Access Compliance Report

Public Rights-of-Way

(Curb Ramps)

Intersection ID: 14195	Main Street: CLEVELAND_AV	Cross Street: EAST_BV	Location: SW
ADA ID: 492ED1BF860A	Ramp Type: Perp	Initial Pass/Fail: Fail	Overall Compliance: No
Severity Score: 12.5			
Codes/Mitigation Info/Possible Solution		Field Measurements/Component Compliance

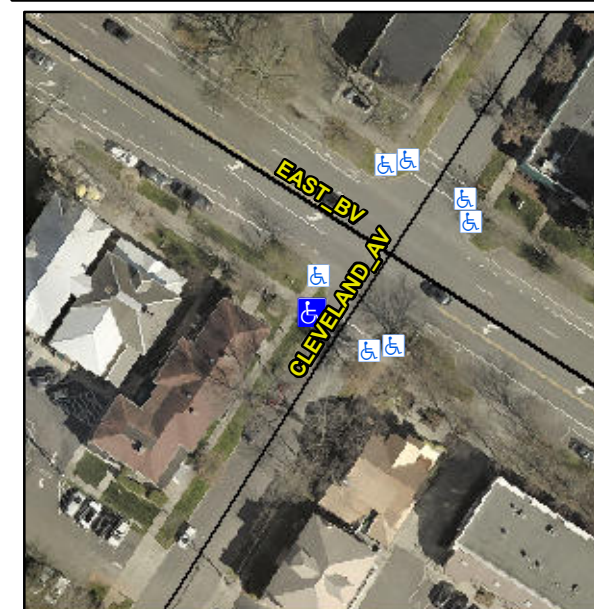
Not Found, R304.2.2

Compliance	Description	Data	Compliance	Description	Data
N/A	Ramp Length (in)	75.0	No	Ramp Slope (%)	8.9
Yes	Ramp Width (in)	72.0	Yes	Ramp XSlope (%)	1.8
N/A	Flare Type LT	N/A	N/A	Flare Type RT	N/A
N/A	Flare Slope LT (%)	N/A	N/A	Flare Slope RT (%)	N/A
N/A	Flare Traversable LT?	N/A	N/A	Flare Traversable RT?	N/A
N/A	Landing Length (in)	N/A	N/A	DWS Provided?	N/A
N/A	Landing Width (in)	N/A	N/A	DWS Contrast?	N/A
N/A	Landing Slope (%)	N/A	N/A	DWS Length (in)	N/A
N/A	Landing X Slope (%)	N/A	N/A	DWS Full Width?	N/A
N/A	Landing Curb? (Y/N)	N/A	N/A	DWS Offset (in)	N/A
N/A	Shared Landing?	N/A			
N/A	Gutter Ponding?	N/A	N/A	Gutter Slope (%)	N/A
N/A	Gutter Lip Ht (in)	N/A	N/A	Gutter X Slope (%)	N/A
N/A	Painted X Walk1?	Yes	N/A	Painted X Walk2?	N/A
	X Walk 1 Direction	To SE		X Walk 2 Direction	N/A
N/A	X Walk 1 Width (in)	110.0	N/A	X Walk 2 Width (in)	N/A
	X Walk 1 Slope (%)	2.6		X Walk 2 Slope (%)	N/A
	X Walk 1 X Slope (%)	2.4		X Walk 2 X Slope (%)	N/A

Remove & Replace Entire Ramp.
